W-REF: P16-335  
25 March 2020

## Response to Auckland Council Further Information Request on Stormwater Matters for Drury East

This memo has been written to summarise the additional stormwater assessments undertaken in response to the Further Information Request (FIR) from Auckland Council for the Drury East Plan Change requests.

Figure 1: Flow comparison – 10yr

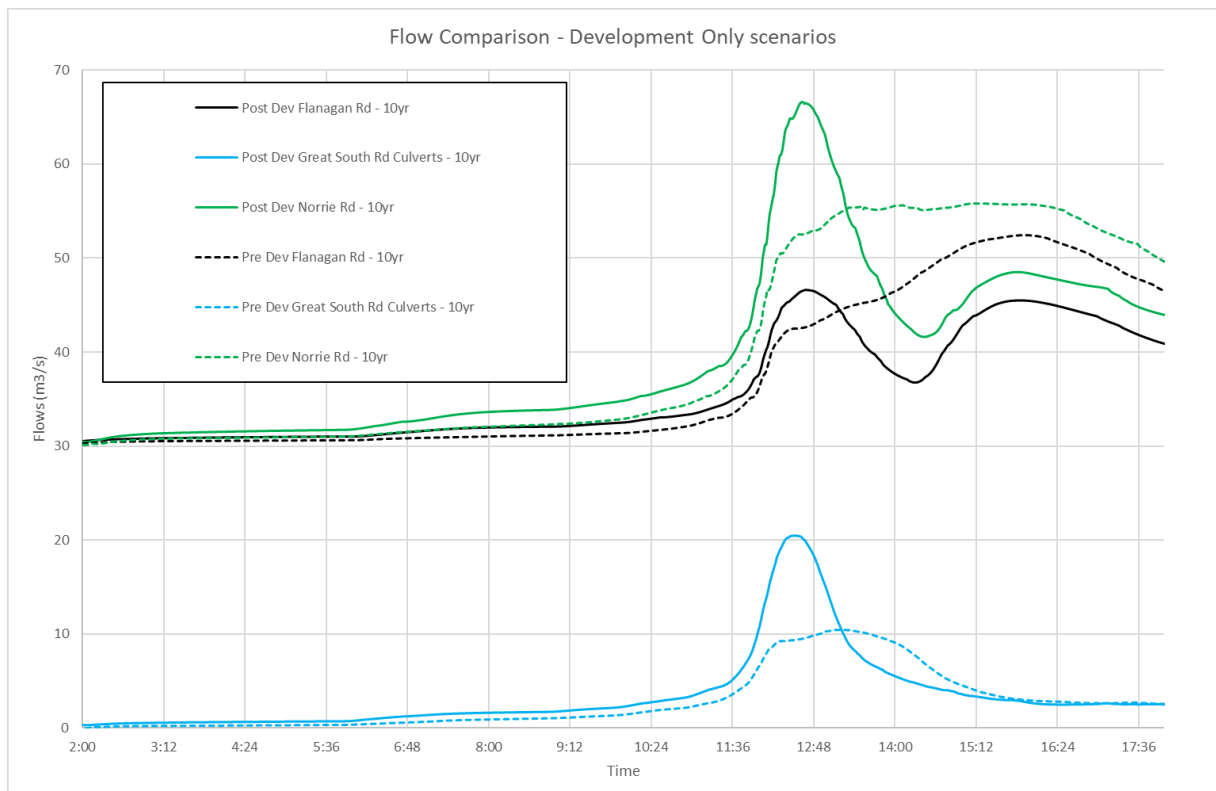
Flows were extracted for the 10yr and 100yr scenarios to understand the differences between the pre and post development scenarios for the 'Development only'. The post development flows are peakier when compared to the pre-development scenario but have shorter time to peak with no lag as seen in Figure 1 and 2 below.

Figure 3: 10yr Flow comparison

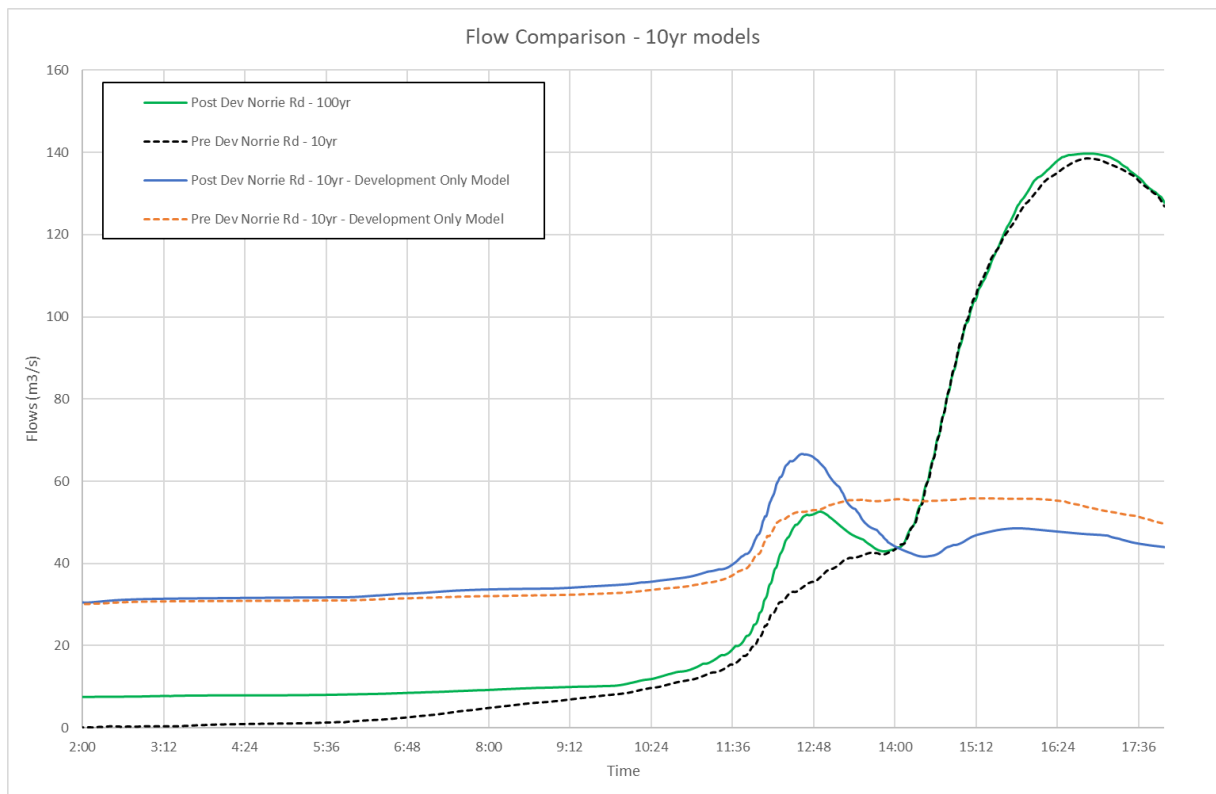
The 10yr flows at Norrie Road bridge were compared for the catchment and 'Development only' models flows which confirm that a 'pass flows' forward approach works better for the proposed development to discharge majority of the flows before the peak of the upstream flows reach Drury township.

This is supported by the building floor risk analysis which shows no increased flood risk to buildings/habitable floors with the 'pass flows forward' approach.
